Access Compliance Report

Public Rights-of-Way

Intersection ID: N/A	Main Street: SHARON_AMITY_RD	Cross Street: N/A	Location: SE
ADA ID: C09AB6D2CAE3	Ramp Type: PerpDiag	Initial Pass/Fail: Fail	Overall Compliance: No
Codes/Mitigation Info/Possible Solution		Field Measurements/Component Compliance

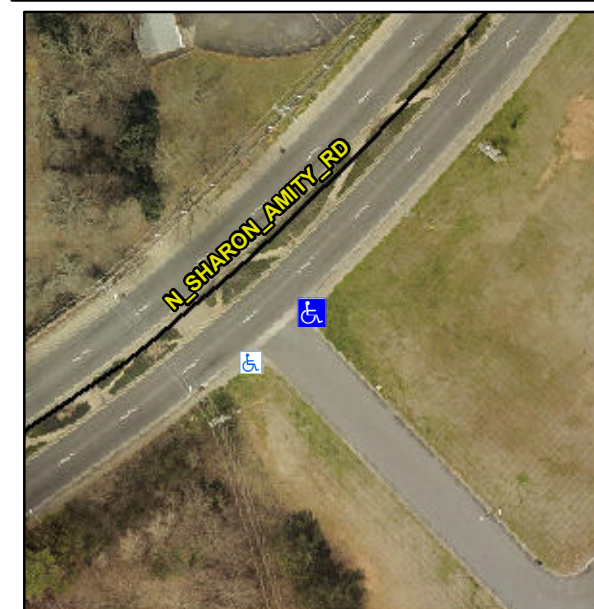
Not Found, R304.5.1, R304.2.2

Compliance	Description	Data	Compliance	Description	Data
N/A	Ramp Length (in)	61.0	No	Ramp Slope (%)	13.7
No	Ramp Width (in)	38.0	Yes	Ramp XSlope (%)	2.6
N/A	Flare Type LT	N/A	N/A	Flare Type RT	N/A
N/A	Flare Slope LT (%)	N/A	N/A	Flare Slope RT (%)	N/A
N/A	Flare Traversable LT?	N/A	N/A	Flare Traversable RT?	N/A
N/A	Landing Length (in)	N/A	N/A	DWS Provided?	N/A
N/A	Landing Width (in)	N/A	N/A	DWS Contrast?	N/A
N/A	Landing Slope (%)	N/A	N/A	DWS Length (in)	N/A
N/A	Landing X Slope (%)	N/A	N/A	DWS Full Width?	N/A
N/A	Landing Curb? (Y/N)	N/A	N/A	DWS Offset (in)	N/A
N/A	Shared Landing?	N/A			
N/A	Gutter Ponding?	N/A	N/A	Gutter Slope (%)	N/A
N/A	Gutter Lip Ht (in)	N/A	N/A	Gutter X Slope (%)	N/A
N/A	Painted X Walk1?	No	N/A	Painted X Walk2?	No
	X Walk 1 Direction	To N		X Walk 2 Direction	To SW
N/A	X Walk 1 Width (in)	N/A	N/A	X Walk 2 Width (in)	N/A
	X Walk 1 Slope (%)	2.2		X Walk 2 Slope (%)	2.8
	X Walk 1 X Slope (%)	0.2		X Walk 2 X Slope (%)	2.9

Remove & Replace Curb Ramp With Two New Directional Ramps or Equivalent.
